Access Compliance Report Public Rights-of-Way (Curb Ramps)

Main Street: ANTONIO_PKWY Cross Street: N/A Location: NW

ADA ID: RPAT220208124059 Ramp Type: Type 1 - Perpendicular Diagonal Initial Pass/Fail: Fail Overall Compliance: No Severity Score: 0

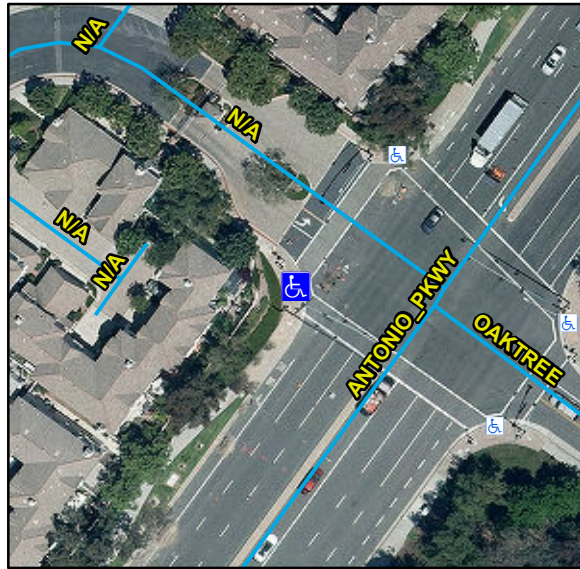
Compliance	Description	Data	Compliance	Description	Data
N/A	Ramp Length (in)	89	N/A	Flare Type LT	
Yes	Ramp Width (in)	54			N/A
Yes	Ramp Run Slope (%)	7.68	N/A	Flare Slope LT (%)	N/A
Yes	Ramp Cross Slope (%)	2.1	N/A	Flare Traversable LT	N/A
N/A	Landing Present	N/A	N/A	Flare Type RT	
N/A	Landing Length (in)	N/A			N/A
N/A	Landing Width (in)	N/A	N/A	Flare Slope RT (%)	N/A
N/A	Landing Run Slope (%)	N/A	N/A	Flare Traversable RT	N/A
N/A	Landing Cross Slope (%)	N/A	N/A	DWS Provided	N/A
N/A	Landing Movement Obstructed?	N/A	N/A	DWS Contrast	N/A
	Landing Movement Type	N/A	N/A	DWS Length (in)	N/A
N/A	Landing Shared	N/A	N/A	DWS Full Width	N/A
N/A	Clear Space	Yes	N/A	DWS Offset Left (in)	N/A
N/A	Clear Space To Crosswalk (in)	48	N/A	DWS Offset Right (in)	N/A
N/A	Marked Crosswalk 1	Yes	N/A	Marked Crosswalk 2	Yes
	Crossing 1 Direction	SE		Crossing 2 Direction	NE
	Marked Crosswalk 1 Width (in)	120		Marked Crosswalk 2 Width (in)	120

N/A	Ramp Inside Crosswalk 1	Yes	Yes	Ramp Inside Crosswalk 2	Yes
	Crossing 1 Slope (%)	1.5		Crossing 2 Slope (%)	0.2
	Crossing 1 Cross Slope (%)	1.38		Crossing 2 Cross Slope (%)	2.6
N/A	Gutter Ponding	N/A	Yes	Curb Slope	0.5
No	Gutter Lip Height (in)	0.25		Road Run Slope (%)	4.99
N/A	Gutter Run Slope (%)	N/A		Road Cross Slope (%)	1.6
N/A	Gutter Cross Slope (%)	N/A			
Yes	Overall Surface Condition: Acceptable		No	Perp Joint Present	No
	Cross Gutter Present?	No		Spandrel Present?	No
	Replace Cross Gutter?	N/A		Replace Spandrel?	N/A

Remove & Replace Curb Ramp With Two New Directional Ramps or Equivalent. Grind Gutter Lip.

R204.3, R302.7.2, STD 1115
